SERVICE BULLETIN

Inspection of Neuform 3-Bladed Variable Pitch Propeller Installation

SB-LTUL-CT__-02;
SB-LTUL-CT2k-03
SB-LTUL-CTSW-05;
SB-LTUL-CTLS-01

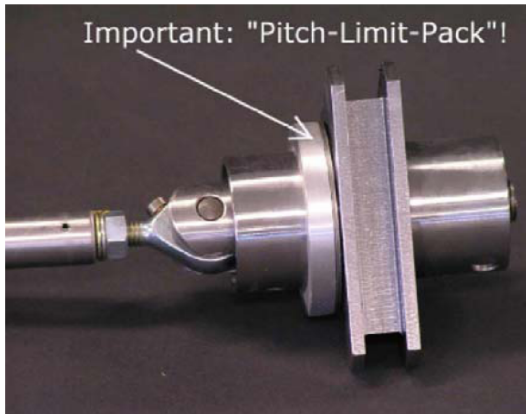
Adjustment of the propeller is done by adjustment of the actuation mechanism located behind / above the propeller gearbox. To achieve identical adjustment of the propeller after conduct of the TA and TM, the following two points have to be considered:

- The actuation mechanism, including the swivel head joints, must not be misadjusted at all. It is highly recommended to mark the position of the swivel head joints including nuts with paint.

- The pitch limiter package within the actuation rod may not be altered.

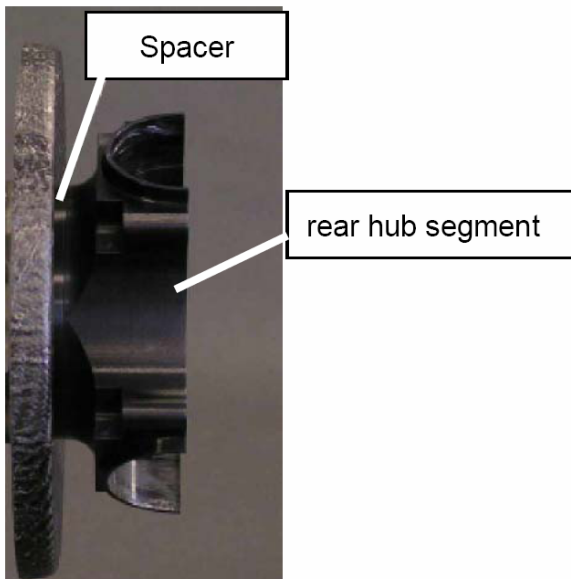
To conduct TM-08-01 Neuform it is sufficient to send the rear hub segment and the spacer to Neuform or to one of the workshops qualified by Neuform to perform TM-08-01.
